ITS59132		01/06/2021
<b>SECTION:</b>	580 - Wheelchair Lift	
<b>WRITTEN BY:</b>	Devin Draward	
<b>SUBJECT:</b>	FR2E/BR2E SWITCH ASSY. CAM SERVICE BULLETIN	
<b>ISSUE:</b>	Field reports have indicated that the switch cams need re-adjustment/tightening after a few cycles of the ramp.	
<b>SUMMARY:</b>	Perform a proactive check of switch assembly cams for proper torque.

**Subject:** SWITCH ASSY. CAM  
**Applicable Products:** FR2E/BR2E  
**Effectivity:** 12/08/20

RSM0068500

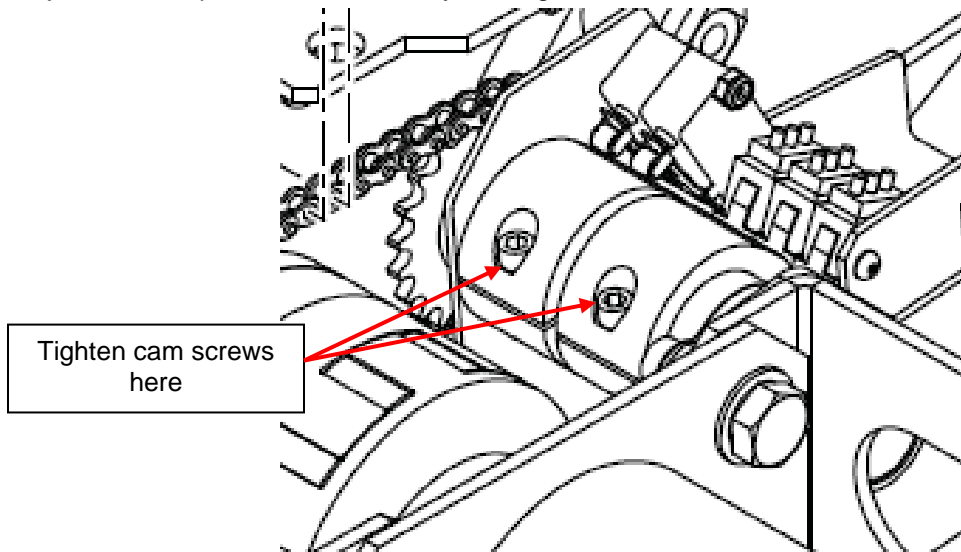
Field reports have indicated that the switch cams need re-adjustment/tightening after a few cycles of the ramp. Inproper torque of the screw holding the cam in place may allow the screw to loosen over time.

1. Manually attempt to turn the position switch cams by hand.

2. If the cam is tight and cannot be moved by hand, no adjustment/tightening is needed.
3. If the cam is loose, minimal force will cause it to move from its at rest position and re-adjustment/tightening will be needed.
4. Re-adjust the cam position as necessary, and tighten the cam screw to 4in-lbs.

5. Cycle the ramp and verify timing of Deploy and Stow functions.
6. If further adjustment is needed, loosen cam screw and repeat steps 4-5 as necessary.
